# M1 Pacific Motorway extension to Raymond Terrace

## Submissions Report

June 2022

**Figure 5-1** shows the location of the project refinements that are documented in this section.

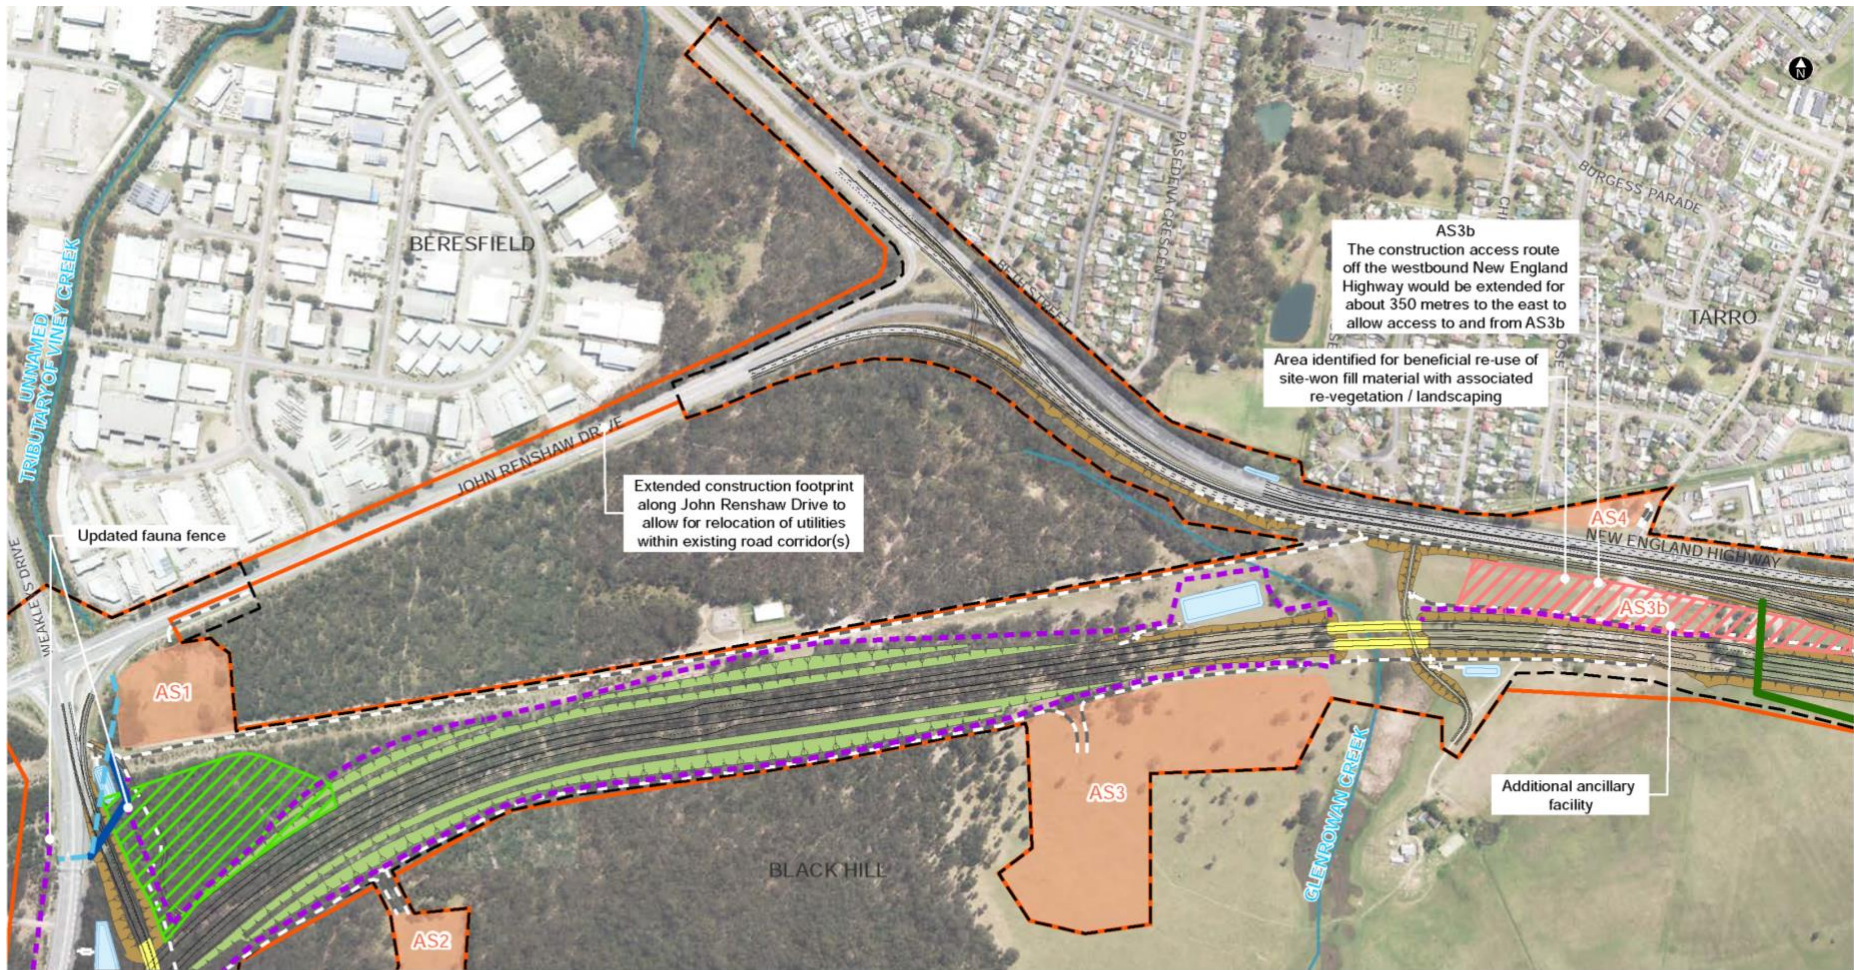
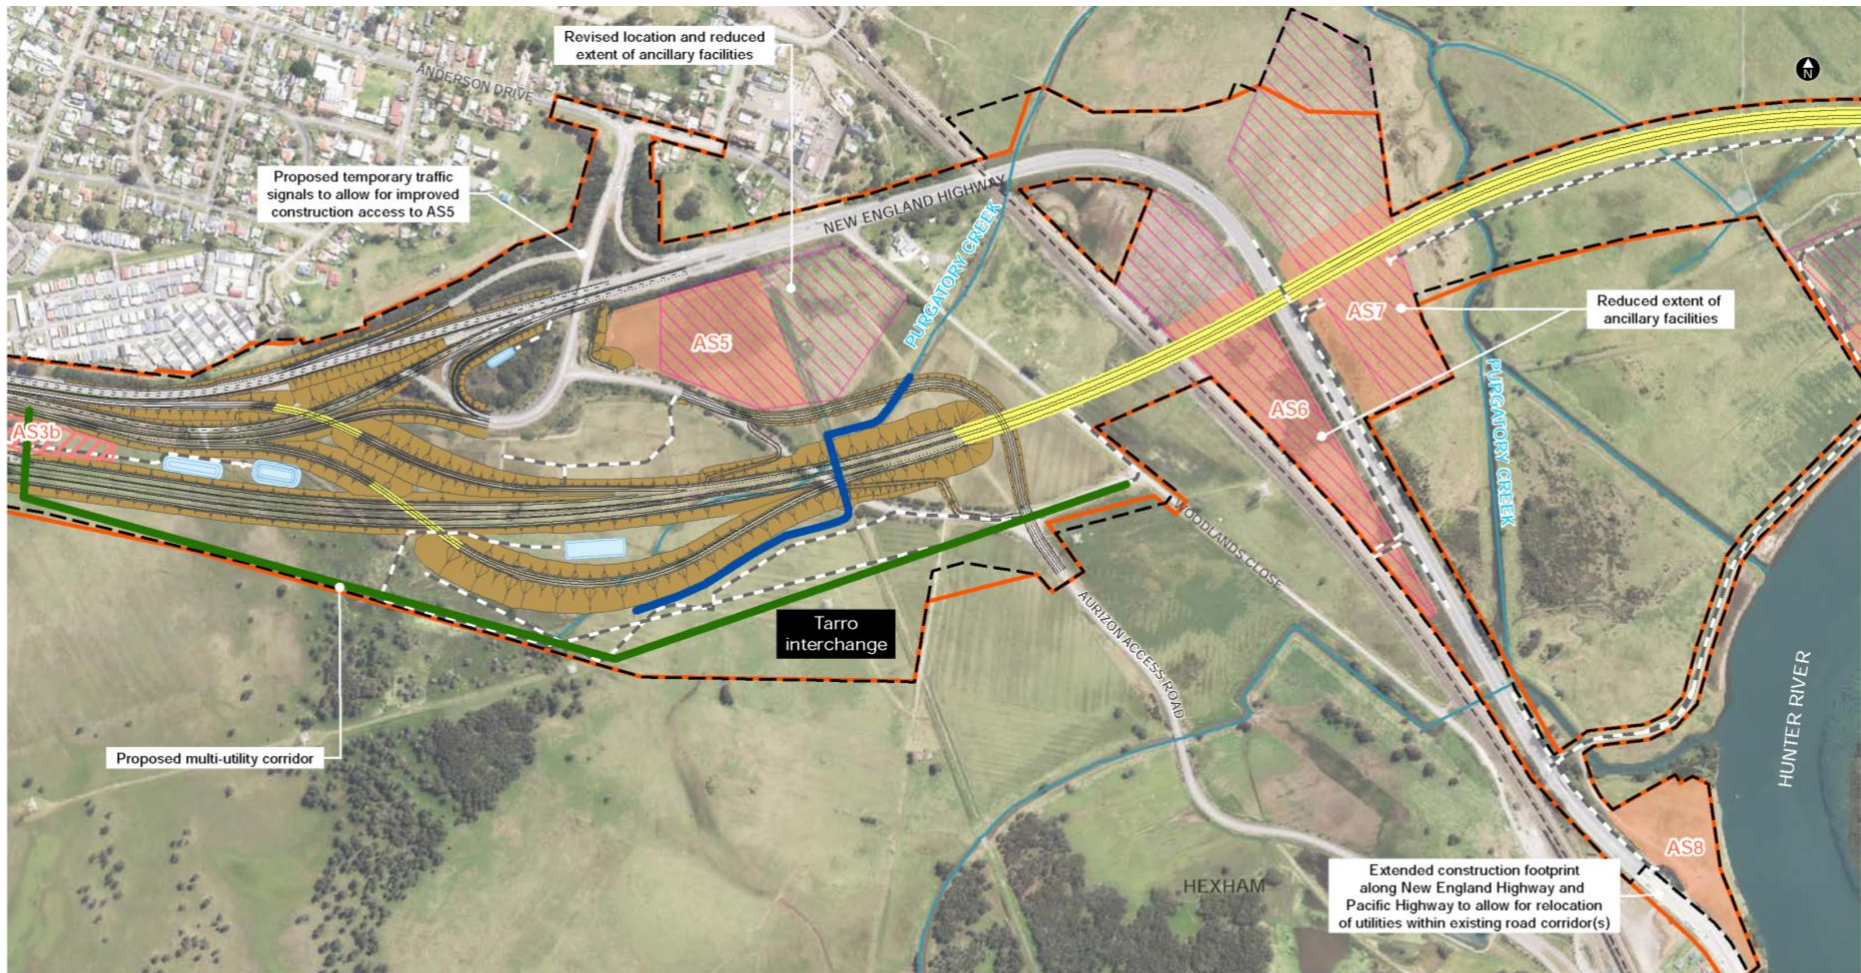
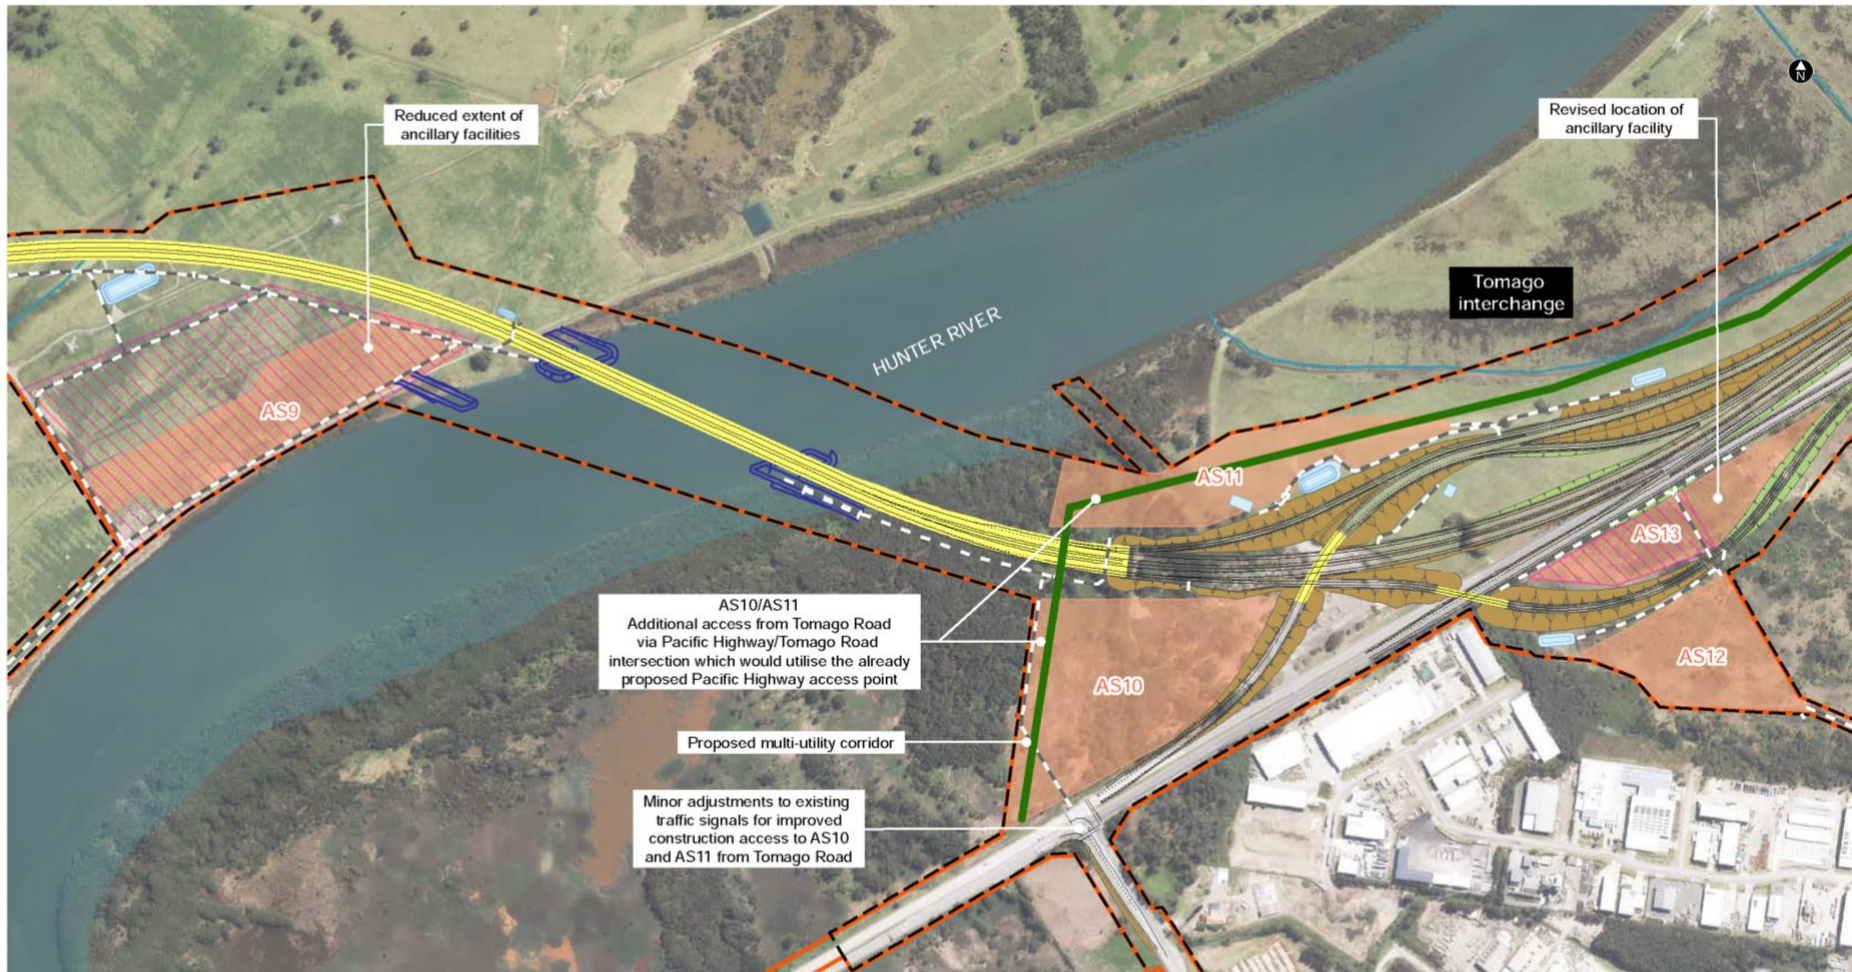
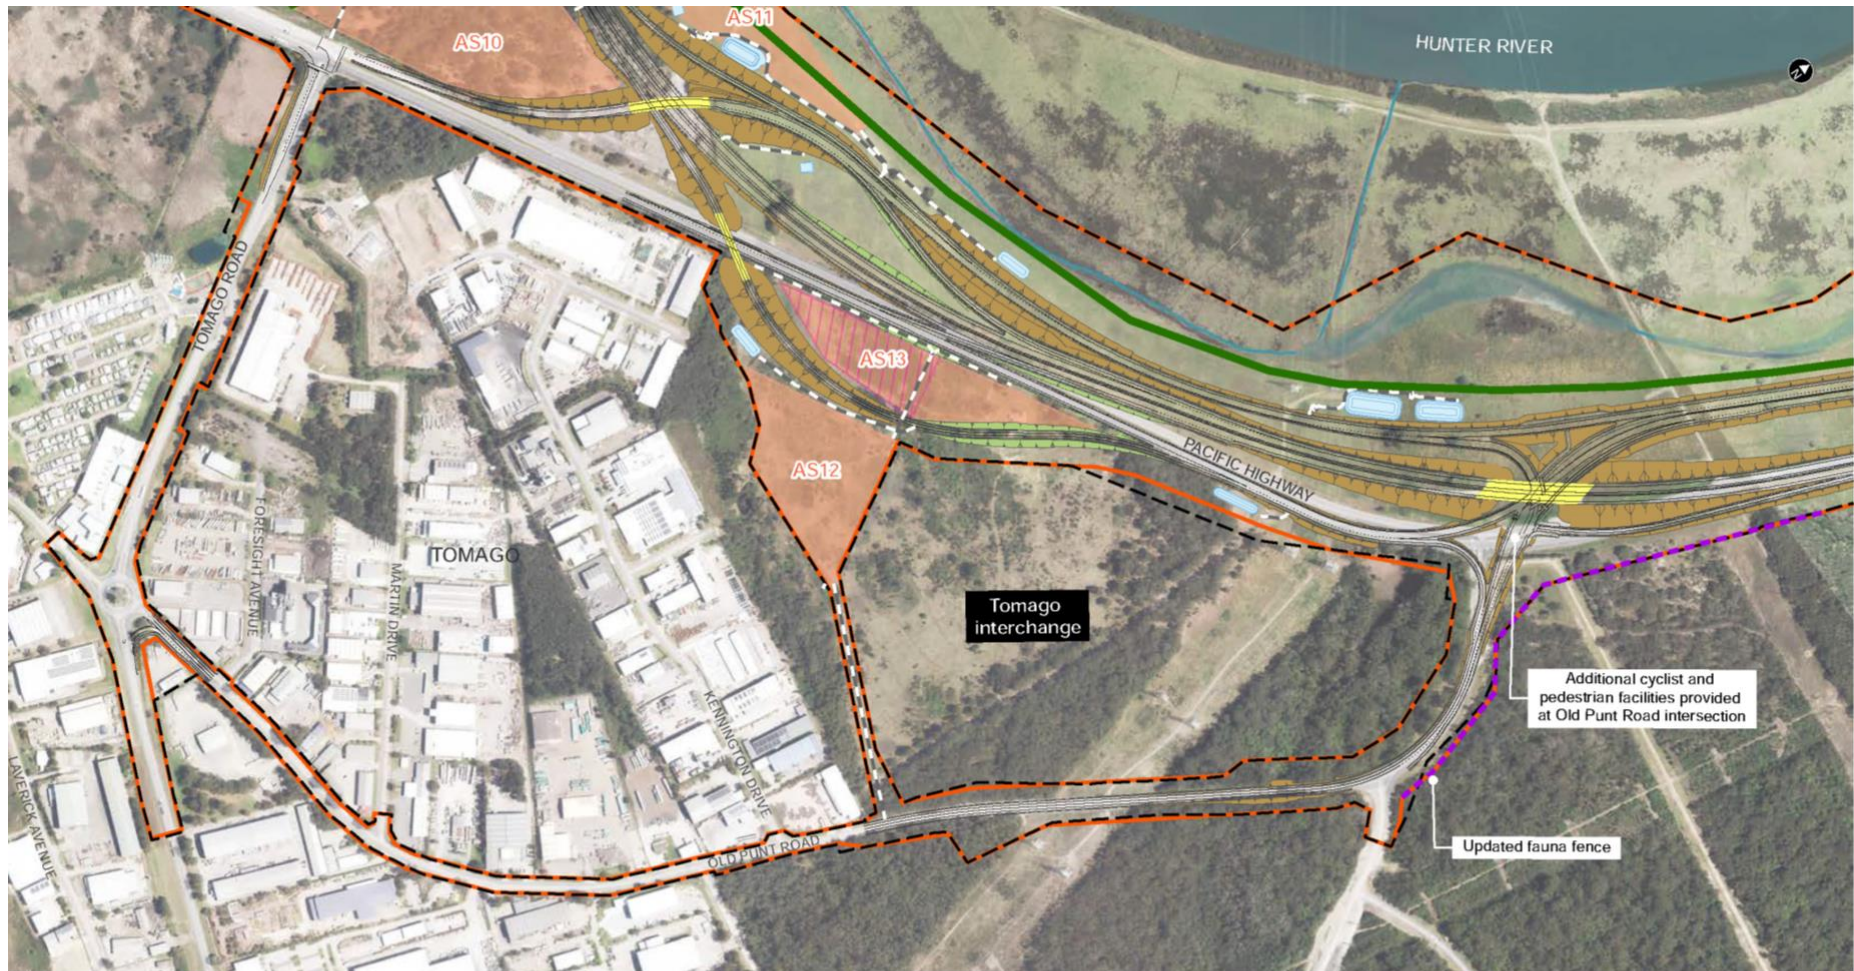
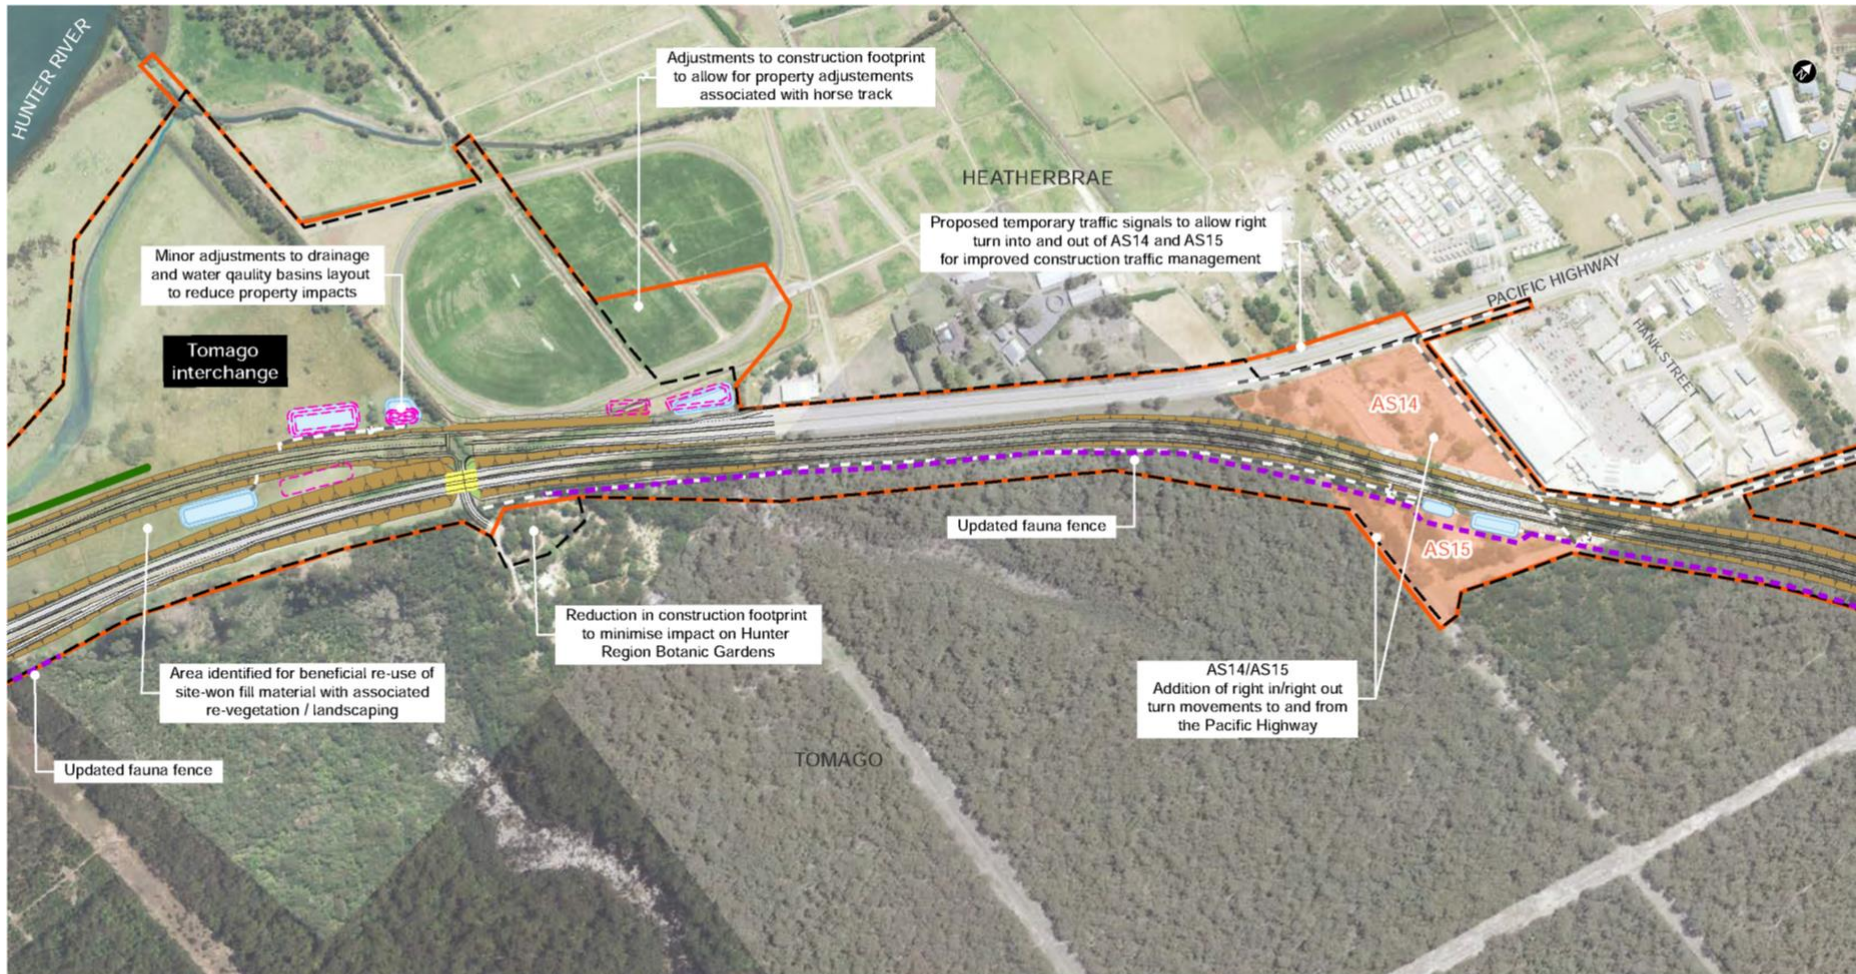
The southbound M1 Pacific Motorway merge lane for traffic from the John Renshaw Drive/Weakleys Drive intersection has been extended by about 200 metres to allow for improved merging (refer to **Figure 5-1**). The merge lane extension includes minor widening to the existing M1 Pacific Motorway southbound carriageway and relocation/replacement of the existing adjacent noise wall at this location.

- Grouping of utilities at Tarro and Tomago into 12 metre wide multi-utility corridors:
  - Tarro (refer to **Figure 5-1**) - the multi utility corridor would be about 1.9 kilometres long and generally aligned east-west along the southern side of the main alignment and Tarro interchange. This would require a small increase to the construction boundary at this location.

The construction footprint has been reduced by 1.5 hectares on the western side of the existing M1 Pacific Motorway at Black Hill (refer to **Figure 5-1**). This area forms part of the road reserve and consists of native vegetation that provides koala habitat. This boundary refinement reduces the project impact on koala habitat and has been in response to the DPIE - BCD submission.

The construction and operational project boundaries have been reduced on the southern side of the main alignment south of Old Punt Road (refer to **Figure 5-1**). The minor boundary reduction at this location was made following consultation with the landowner AGL. The boundary refinement reduces property impacts on AGL land and ensures adequate provision for both the project and AGL's approved gas fired power plant project.
